# Access Compliance Report

## Public Rights-of-Way

### (Curb Ramps)

| Intersection ID: 48948                  | Main Street: BIRCHLEY_CR | Cross Street: DAVID_JENNINGS_AV         | Location: NW           |

| ADA ID: 95A7AD70C847                    | Ramp Type: Perp          | Initial Pass/Fail: Fail                 | Overall Compliance: No |

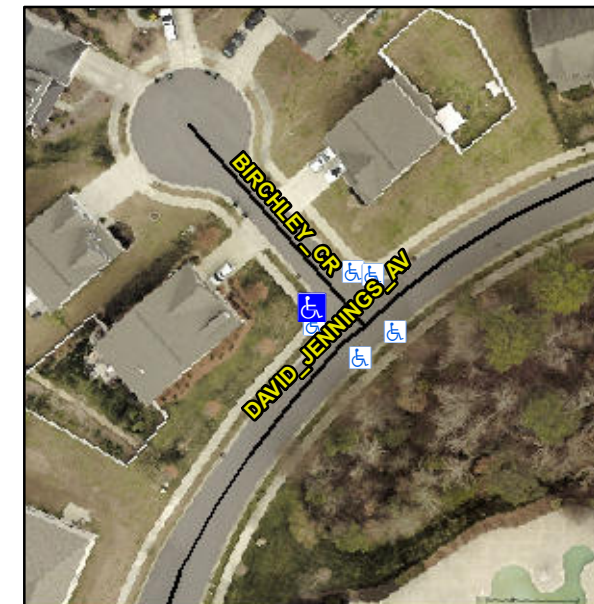
**Not Found, R304.5.1**

| Compliance | Description           | Data | Compliance | Description                 | Data |
|------------|-----------------------|------|------------|-----------------------------|------|
| No         | Ramp Width (in)       | 45.5 | Yes        | Ramp XSlope (%)             | 1.4  |

**Remove & Replace Entire Ramp.**
